South Kensington ASD Space Allocation

From: [Wong Li-Fong](#) on behalf of [SSL Space Allocation](#)
To: [VanVuuren Schalk](#); [Maguire Susanne](#); [Anderson Scott](#); [Penderis Lynette](#); [Godwin Paul \(CD\)](#); [McMorrow Mike](#); [Lovatt Daniel](#); [Castle Jeremy](#); [Godwin Paul \(CD\)](#)
Cc: [SSL Space Allocation](#); [Fernihough Anthony](#); [Area Manager South Kensington \(Abdul Rahim\)](#); [TOM Earl's Court \(Brenda Ani\)](#); [Space Allocation Requests](#); [Terribili Peter](#); [Dennis William](#); [Boot-Handford Nicholas](#); [Broughton Martin](#); [Doherty Martin](#); [Rawlings Ian](#); [Broughton Martin](#); [Li Mark](#); [Lemon Paul](#); [Lees Matthew](#); [Henderson Jennifer](#); [Lemon Paul](#); [Phiniefs Christopher](#); [Skinner Bruno](#); [Butler Steve](#); [Burgess Nick](#); [Choules Dean](#); [Scorza Roberta](#)
Subject: SA29402 South Kensington – Sloane Square (D109, D108) - Space Approved U21
Date: 20 December 2016 14:12:36

With reference to your request for space at **South Kensington – Sloane Square** under Reference **SA29402**

Dimensions / placement of asset (continued):

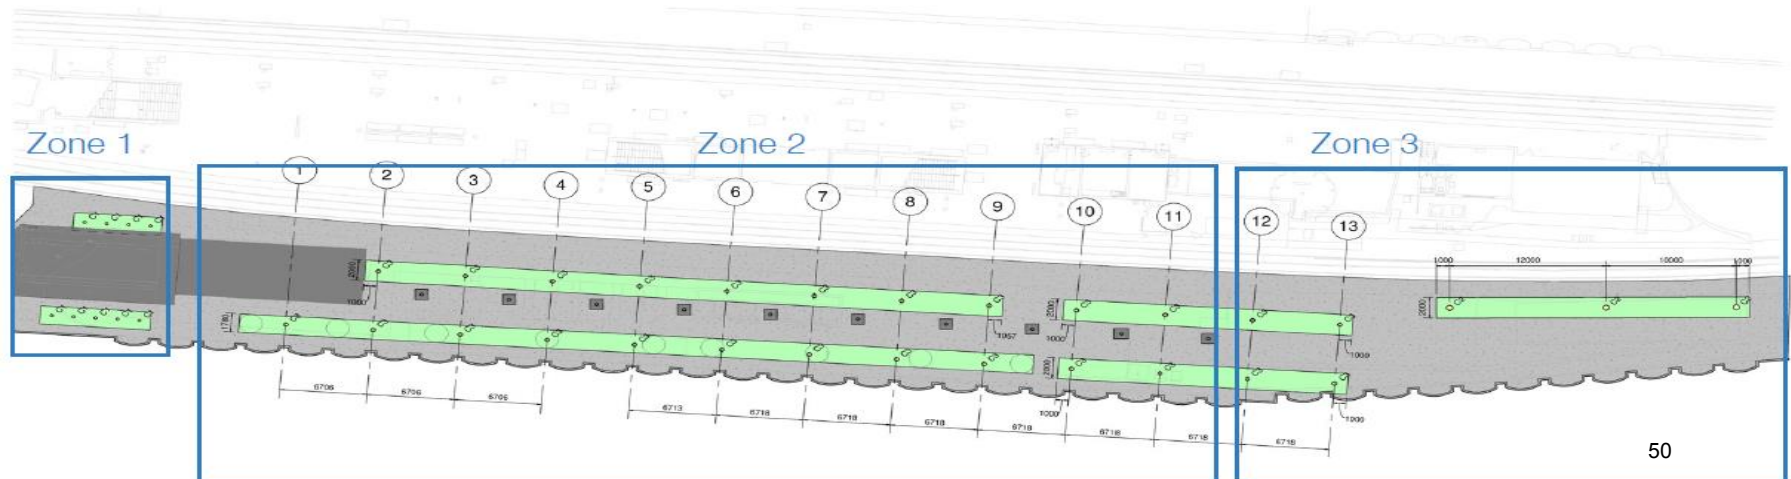
I am not 100% sure about the details of SA29402 and the proposed columns or walls (ref: ASD Space Allocation - page 8 zone 1) to support the escalator block bridging slab. I did have discussions in July'16 with Commercial Development to the effect that we would continue with our immediate plans to modify the external staircase with a view to revisit the construction at some point in the future; when the ASD plan is more advanced and detailed.

1 Ticket Hall & Basement level
Scale 1:250

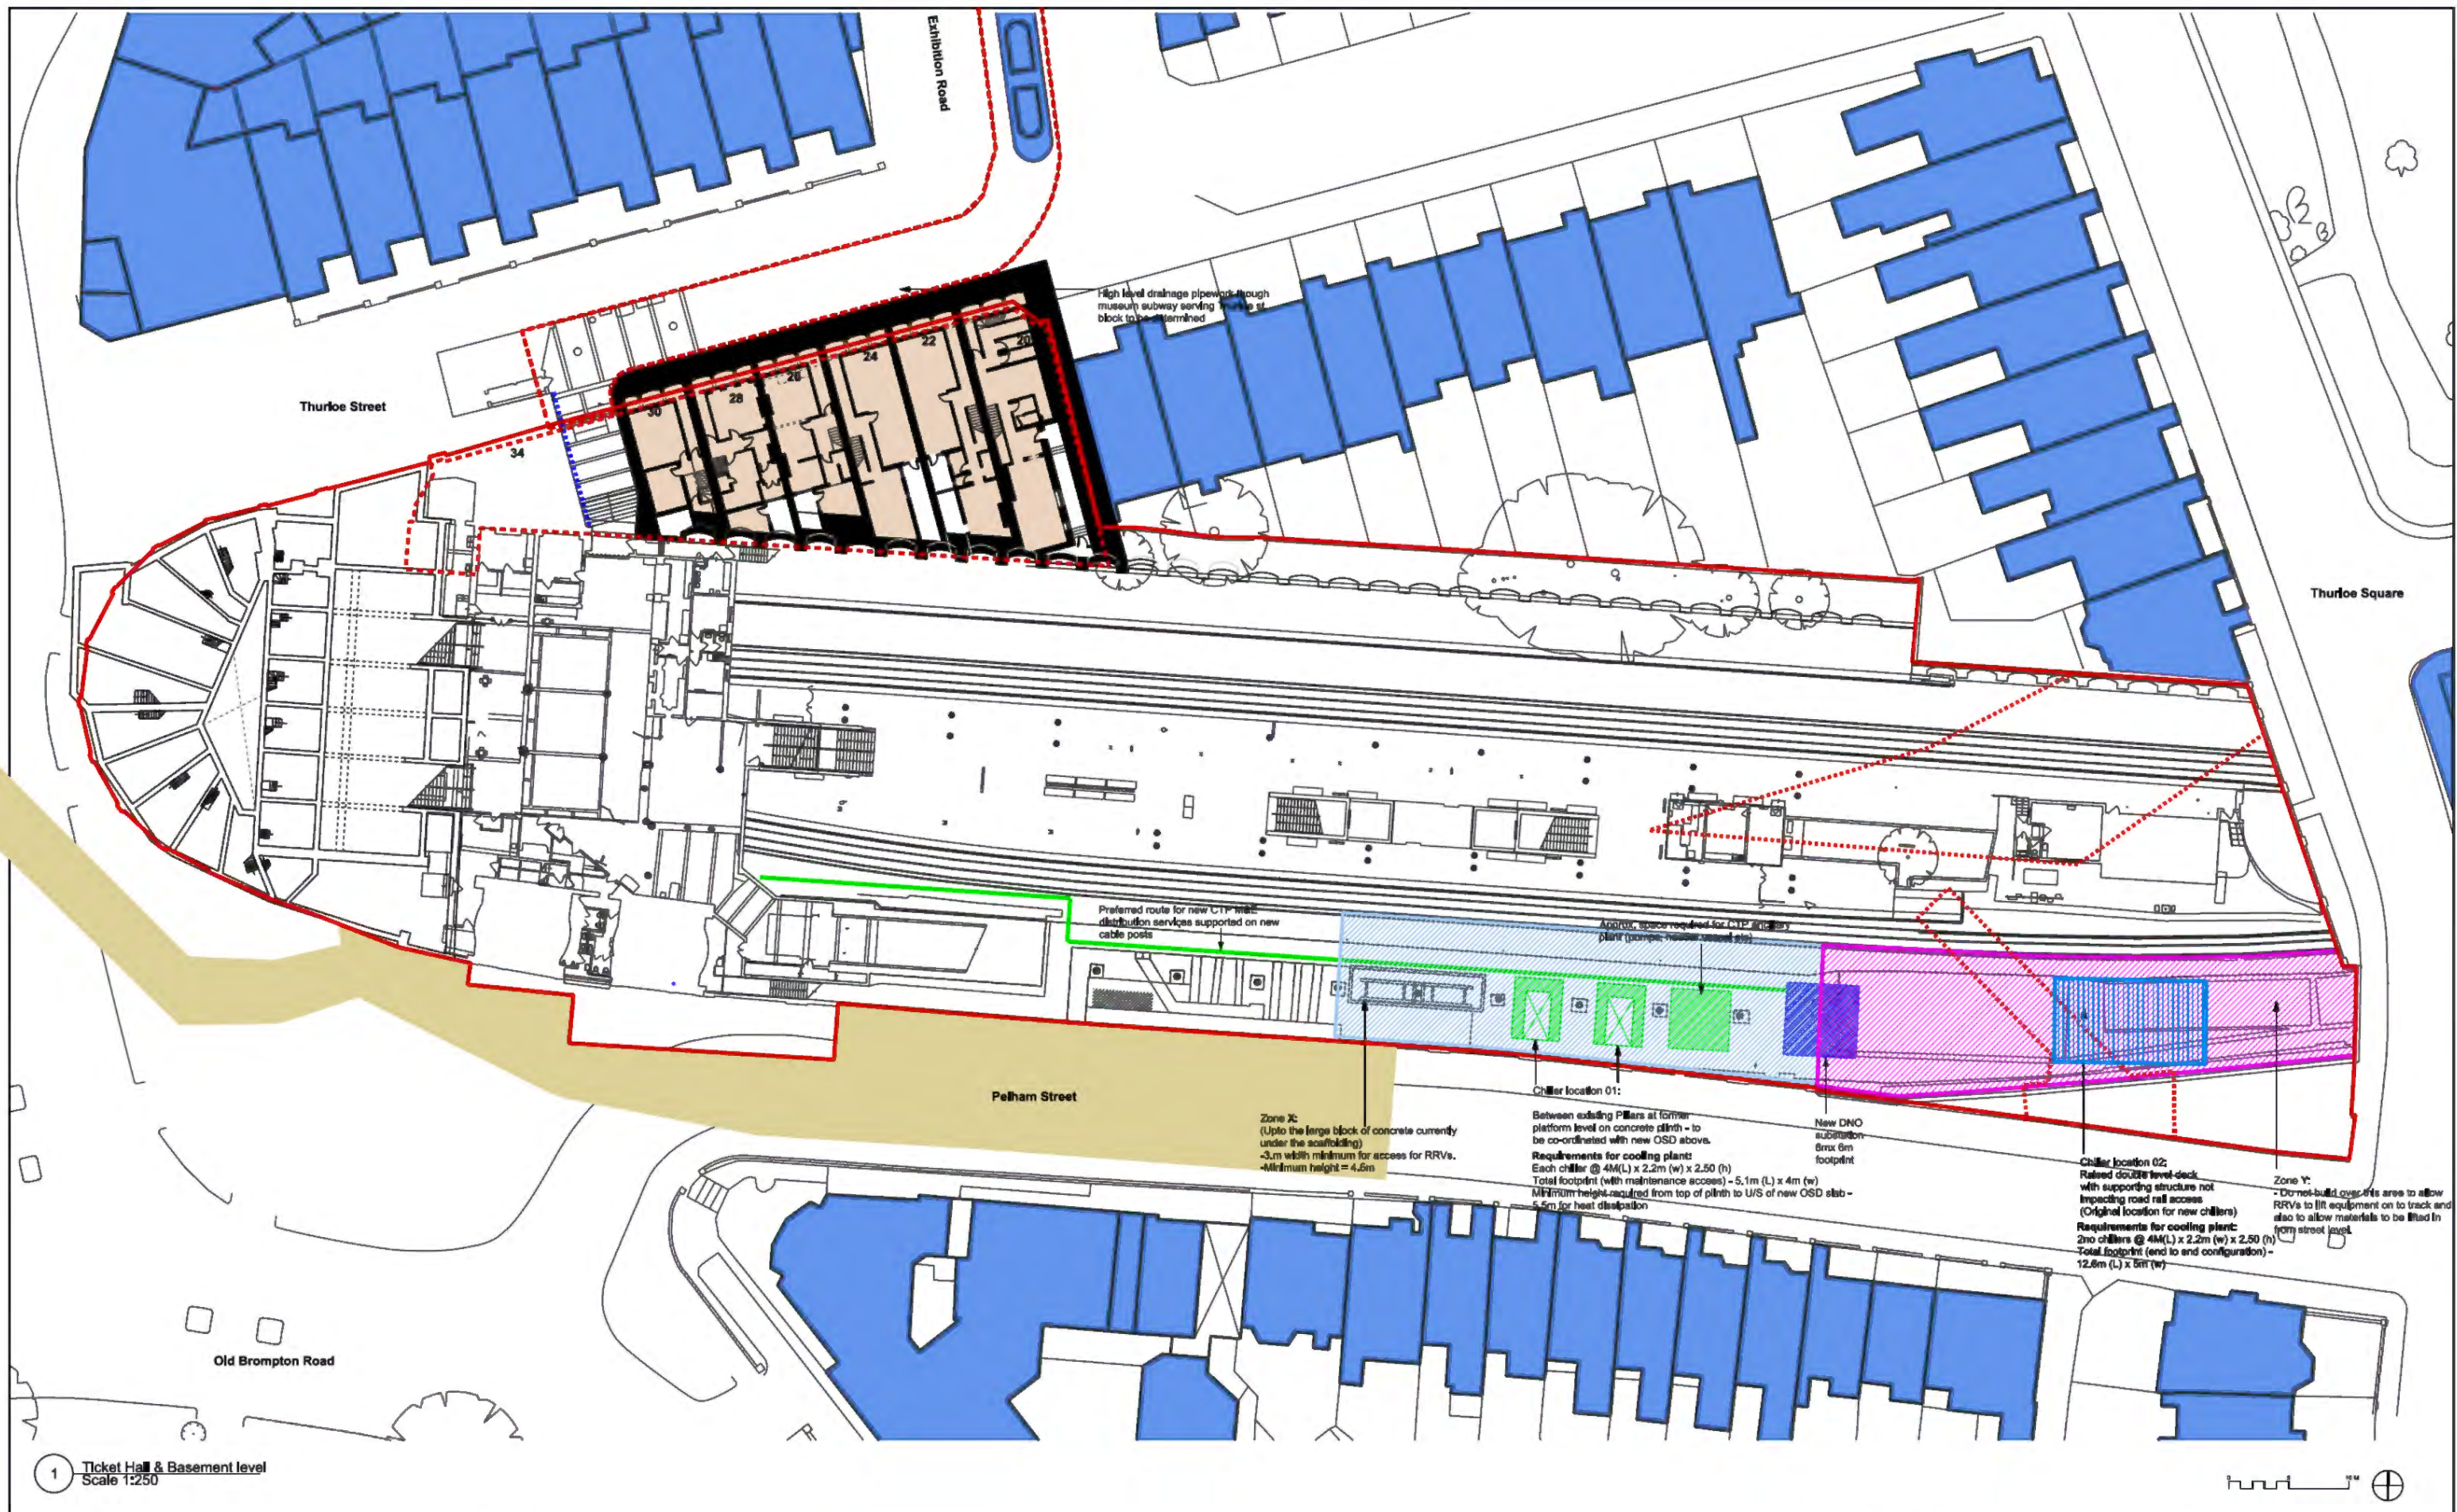
<p>6. SVV advised that the ventilation grille to the Oxblood will need relocating as the ASD development will be built up against the Oxblood. SVV mentioned that the grille could be located on the roof or an alternative side of the Oxblood. This will be developed at the next stage of design. It is understood that the relocation will not cause any issues to 'Cooling the Tube' programme.</p>	<p>note</p>
<p>7. 'Cooling the Tube' programme will commence circa 2024 subject to item 2 above (i.e. may not be required).</p>	<p>note</p>
<p>8. SVV advised that the ASD team is targeting the following construction dates:-</p> <p>8.1. Start on Site – beginning Q1/2019</p> <p>8.2. Completion – end Q4/2022</p>	<p>note</p>

9. There was general consensus that the ASD proposal will not adversely affect the 'Cooling the Tube' programme. WD advised that 'Cooling the Tube' have no objection to the proposed ASD design/scheme at this stage.

SKETCH 1: ITEM 4(a)

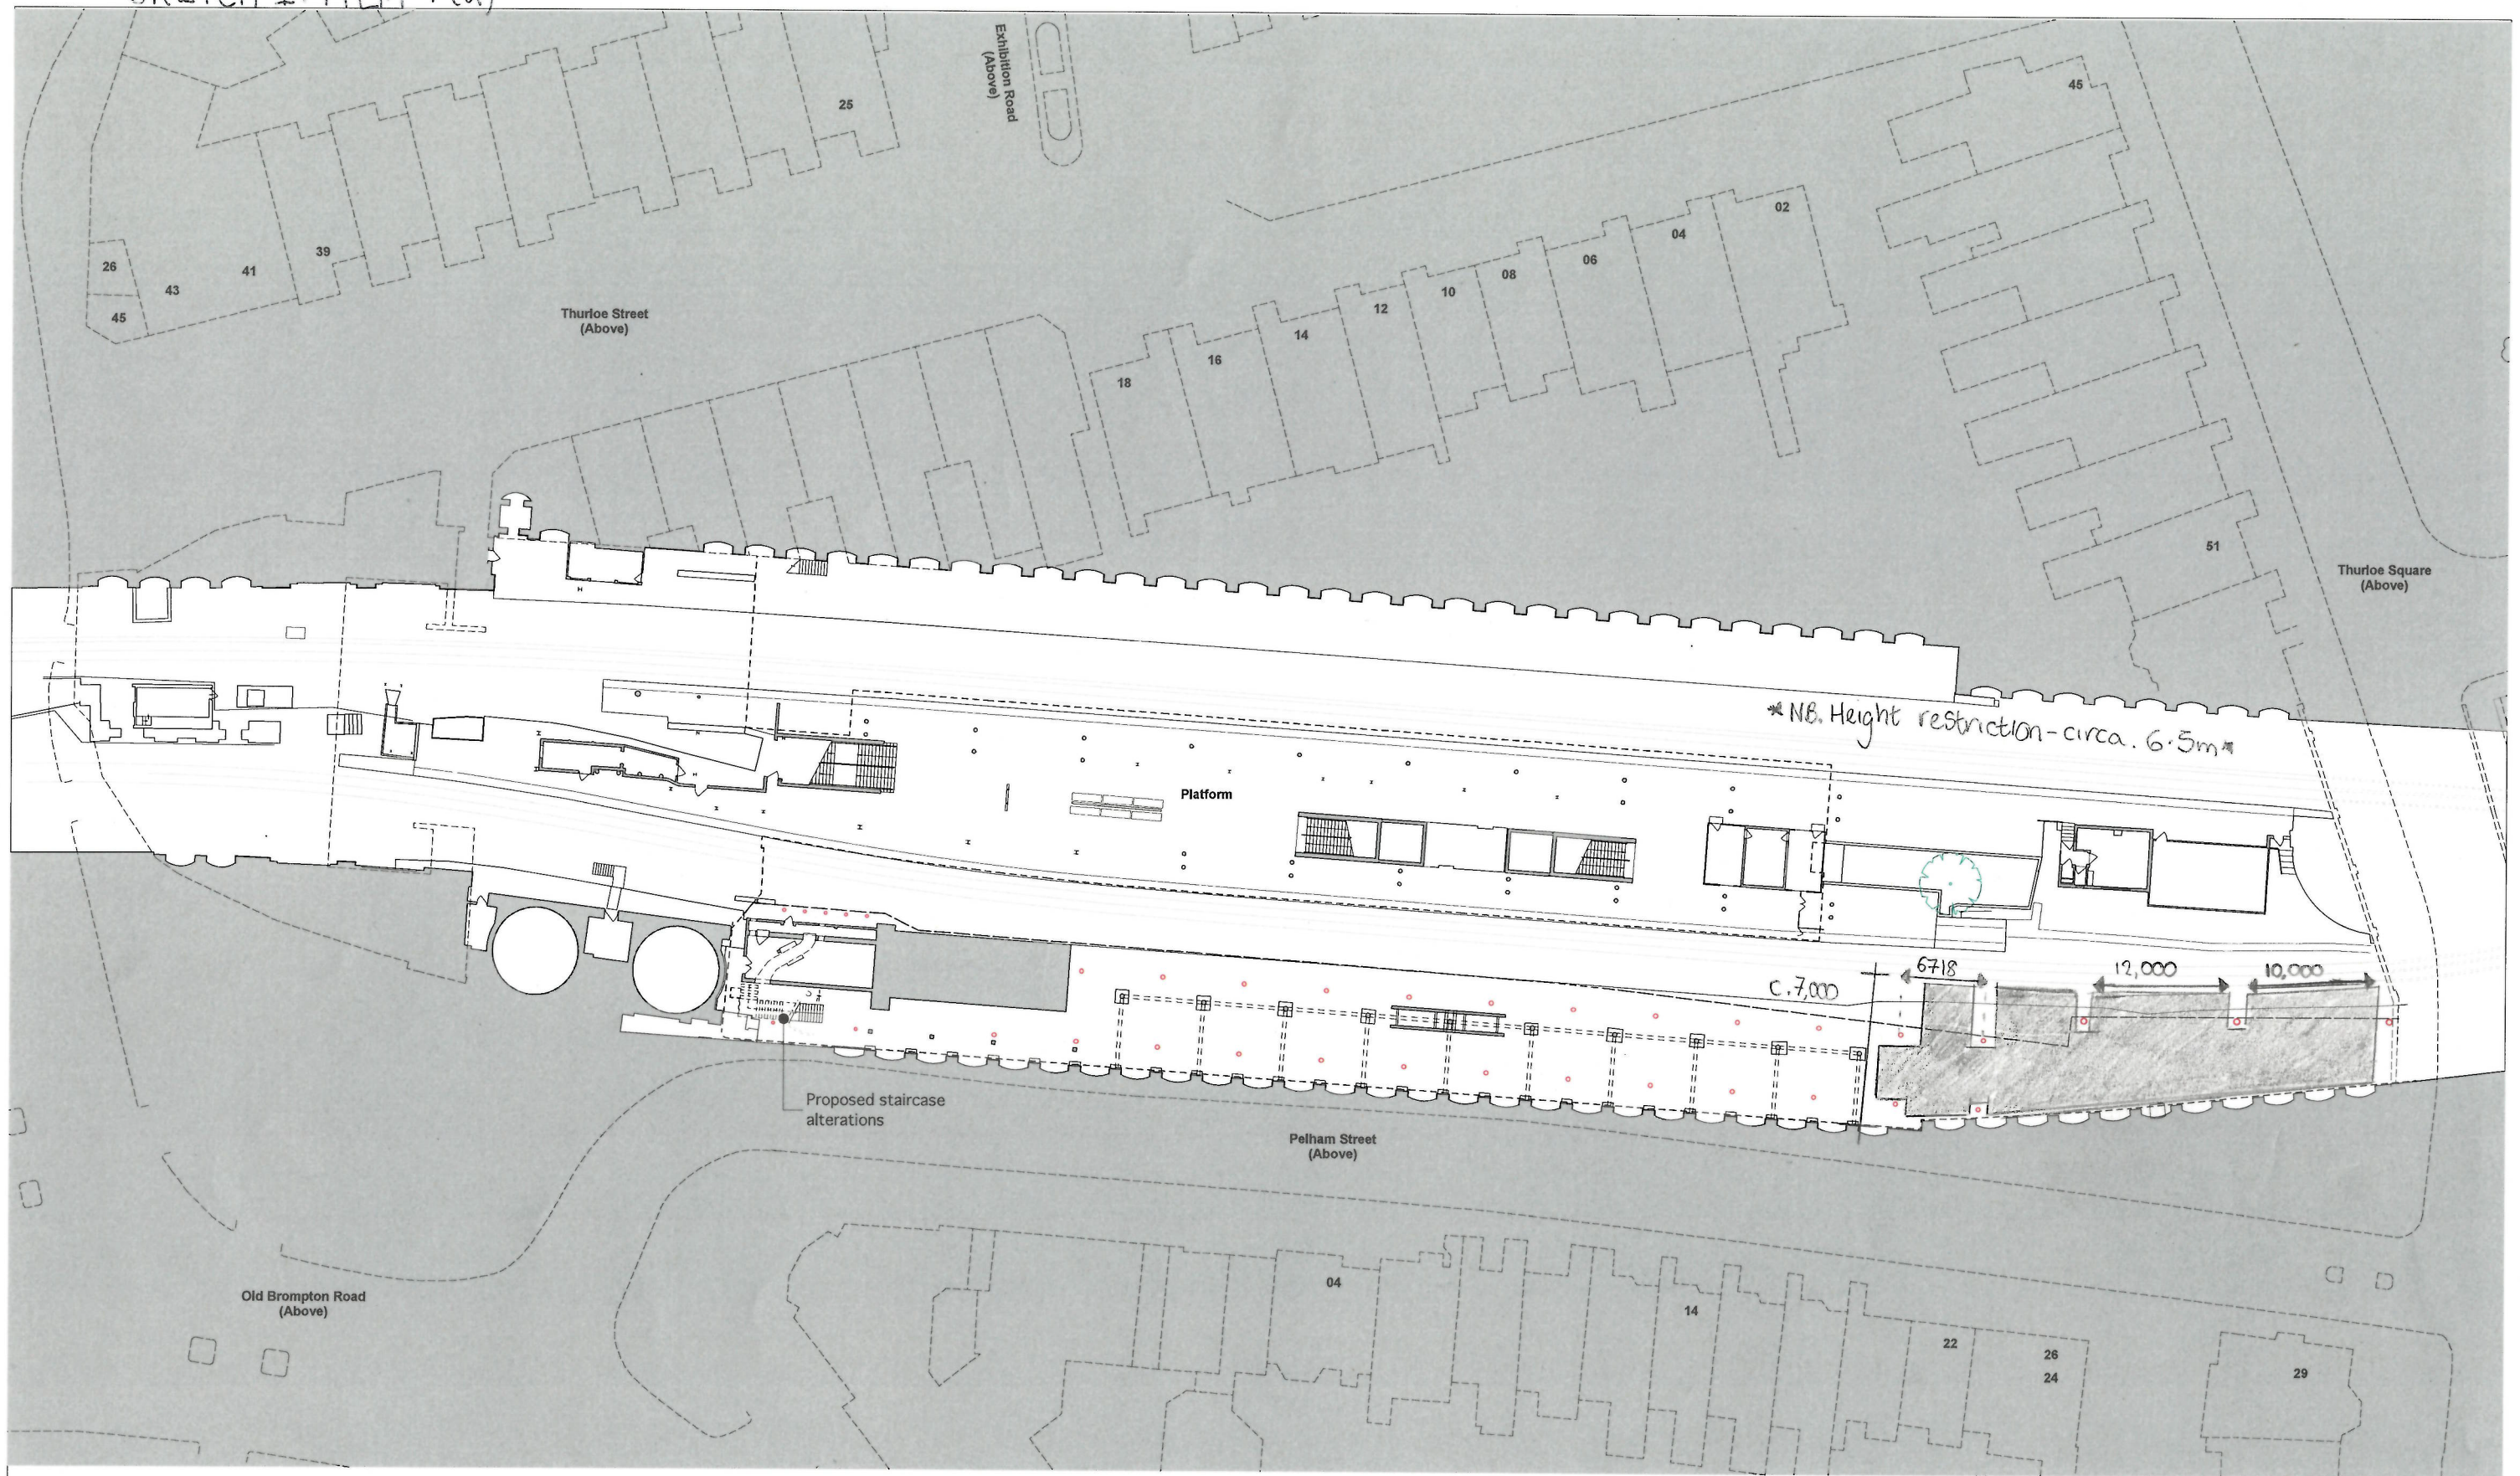
e) The above opportunities need to be explored by both ASD and RRV/RRAP/Track partnership ASAP.	ALL
5. MB suggested that Ian Rawlings would be best placed to supply the dimensions of the plant and their spheres of operation, i.e. turning circles, etc. The ASD design team will then be able to assess the spatial requirements for the base case. SM/MB to liaise with Ian Rawlings in order to confirm this. The current design assumes a 12m clear width (between columns) and circa 6.5m clear height. This has been based on previous conversations with RRV/RRAP representatives.	MB/SM

8. There was general consensus that the ASD proposals could be delivered whilst maintaining a sufficient space for RRV hardstanding and operation.	note
